# SERVICE No. 1103B BULLETIN

Date: November 25, 2003 (S)

<b><u>SUBJECT:</u></b>	<b>ENGINE MOUNT INSPECTION</b>
<b><u>MODELS AFFECTED:</u></b>	<b><u>SERIAL NUMBERS AFFECTED:</u></b>
PA-46-310P Malibu	46-8408001 through 46-8408087, 46-8508001 through 46-8508109, 46-8608001 through 46-8608067, and 4608001 through 4608140
PA-46-350P Mirage	4622003 through 4622200 4636001 through 4636319
PA-46-500TP Meridian	4697001 through 4697071; 4697075 through 4697096; 4697100; 4697101; 4697103 through 4697112; 4697114 and 4697116

**(PA-46-310/350P)**  
**Typical Engine Mount**  
**(Arrows indicate Engine Mount Actuator Attach Feet)**  
**Figure 1A**

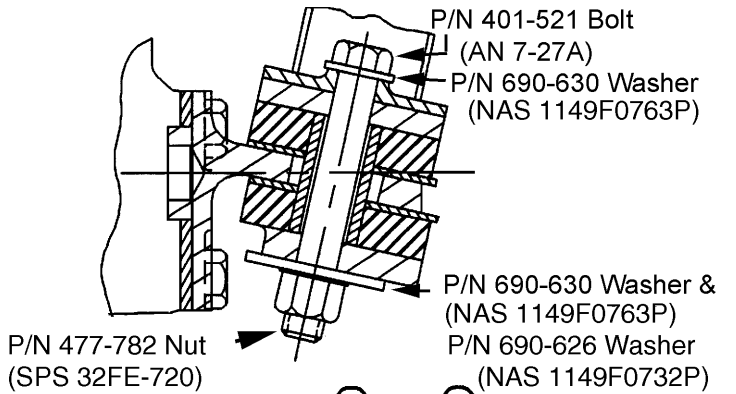
**PURPOSE:** It has been determined that cracks may develop on the engine mount in the area of the nose gear actuator attach feet (see Figure 1A). This condition typically occurs when the nose landing gear is subjected to excessive loads, possibly through hard landings, rough field operations, excessive speed turns and/or improper towing of the aircraft.

1. Clean the engine mount actuator attach feet area.
2. Remove the paint or Dinitrol AV8, if the paint was previously removed and covered with Dinitrol AV8, from the feet (ref. Figure 1A).

3. Visually inspect the engine mount actuator attach feet for cracks.
4. Perform a 'liquid penetrant inspection' of the engine mount actuator attach feet for cracks per AC 43.13-1B, Chapter 5, Section 5.

Figure 2  
Old Engine Mount  
Weld Indicates Two (2) Piece Foot

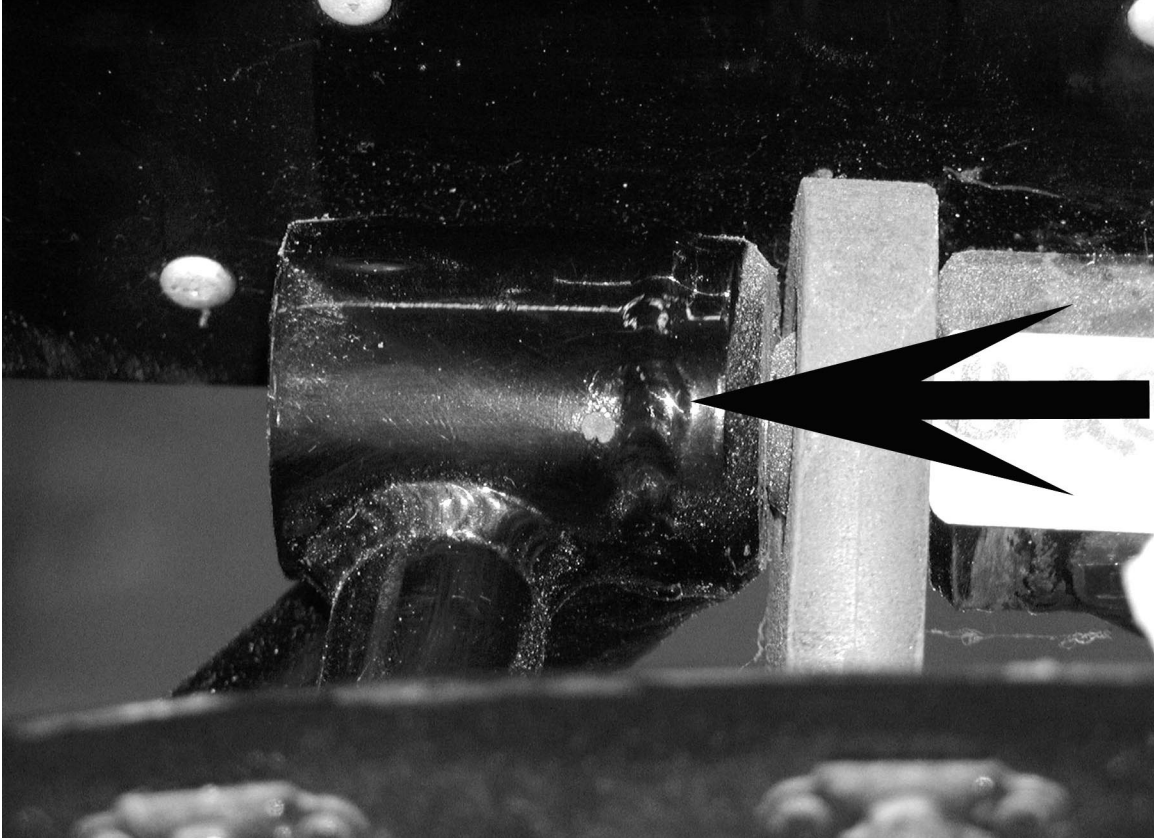
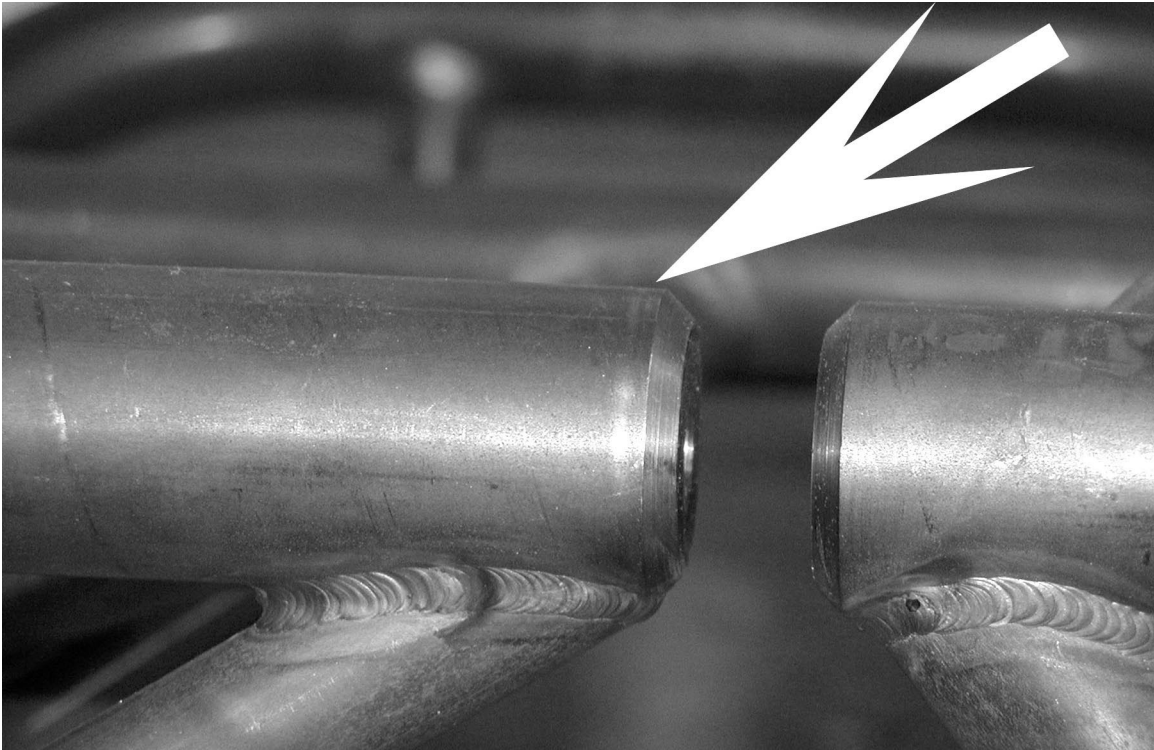
1. If cracks are found on the engine mount, replace with the engine mount listed in Table 1 for the applicable aircraft type. Insure the new engine mount has the one (1) piece feet (see Figure 3). The old engine mount (see Figure 2) has a two (2) piece welded foot. This welded area is where the crack's in the engine mounts have been found. Replace engine mount per the Aircraft Maintenance Manual, Chapter 71-00-00.

5. If a crack appears in either of the actuator attach feet, the engine mount must be replaced before further flight. The installation of the appropriate engine mounts (see Table 1 on Page 2), with the one (1) piece feet (see Figure 3) constitute compliance with PART I and PART II of this Service Bulletin.

NOTE: When installing the new engine mount, pay close attention to the nose gear actuator connecting hardware to ensure the correct locknut is used (New Piper part number 404-891, MS 20365-720C). Additionally, check for proper thread engagement between the bolt and nut by ensuring at least one thread of the bolt protrudes through the nut, per AC43-13B, Chapter 7, Section 3, paragraph 7-37. If there are not sufficient threads exposed after the lock nut, replace the bolt with a longer bolt, New Piper part number 401-509 (AN7-15A). Torque to the standard torque value called in the Maintenance Manual, Chapter 91-10-00, for a 7/16-20 AN7 bolt/MS 20365 nut.
